Item 12

## Probe and noise considerations for Indian Point2

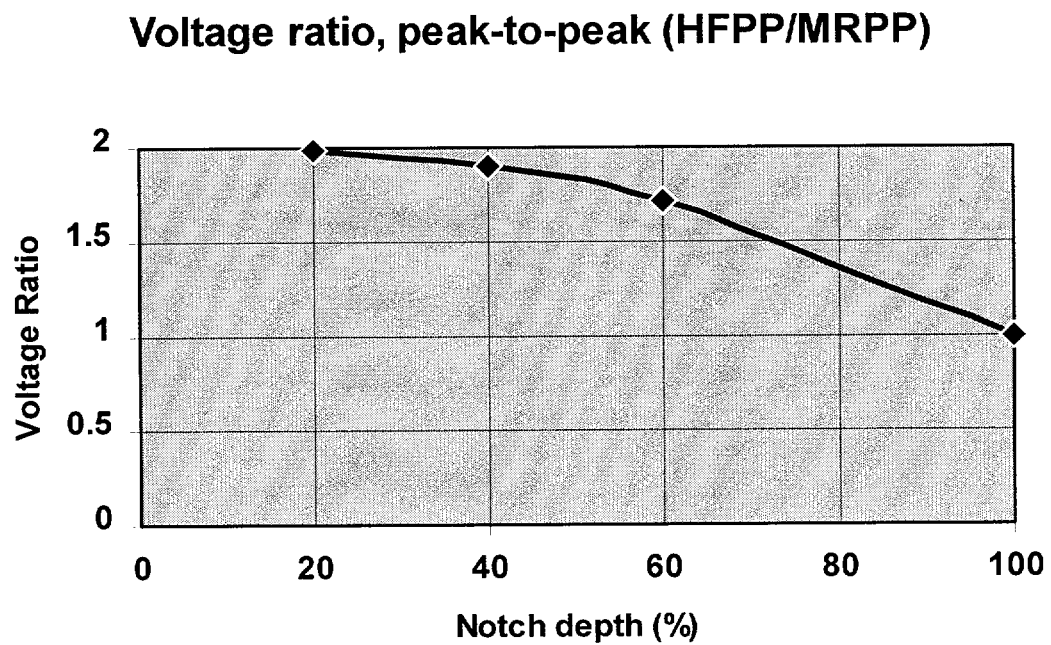
The growth studies should use the same type of probe, since the probe size has a significant effect on the measurements. Instead they used the smaller high frequency probe operated at 400 kHz. The growth studies that I did with the midrange probe showed a definite and considerable growth in voltage amplitude but little average growth in the defect depth. Part of the lack of depth growth could be due to poor signal-to-noise measurements. Both measurements on the standard and measurements on the actual defects show a marked increase in the voltage obtained for the defects. In Figure 1 we show the voltage ratio of the high-frequency, smaller probe to the midrange

probe. Since both probes are set at 20 volts on the 100% deep defect, the ratio is unity at this point. The average ratio of the three defects that had a good measurement of the maximum voltage was 1.42, which would

correspond to a defect about 70% deep. This curve is for the peak-to-peak voltage. The voltage measurement ratios for the vertical component of the high-frequency probe are slightly greater, since it has a larger phase angle.

**Figure 1** Tube 2-71 of SG24 in 1997 at 400 kHz, with circular average filter applied.

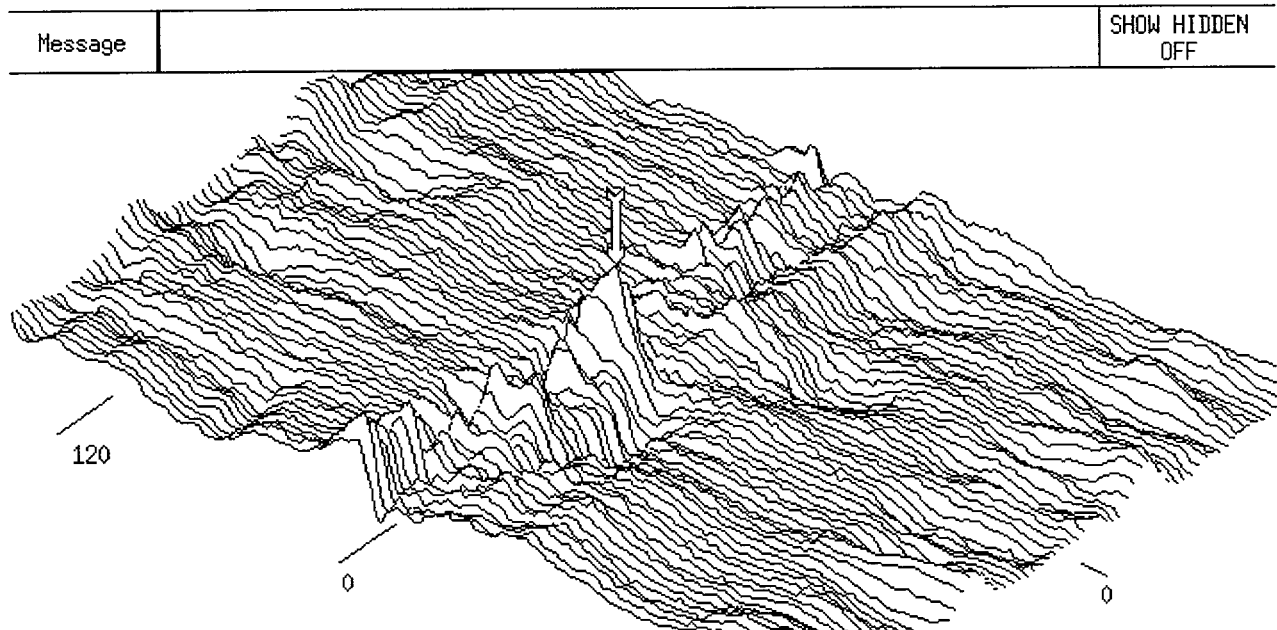
Tube 2-69 and tube 2-87 have defect signals in a relatively clear part of the tube, although neither are particularly large. Tubes 2-5 and 2-72 are similar, and could possibly be detected from the C-

scan. Tube 2-71 and 2-85 need the circular average filter applied for detection.
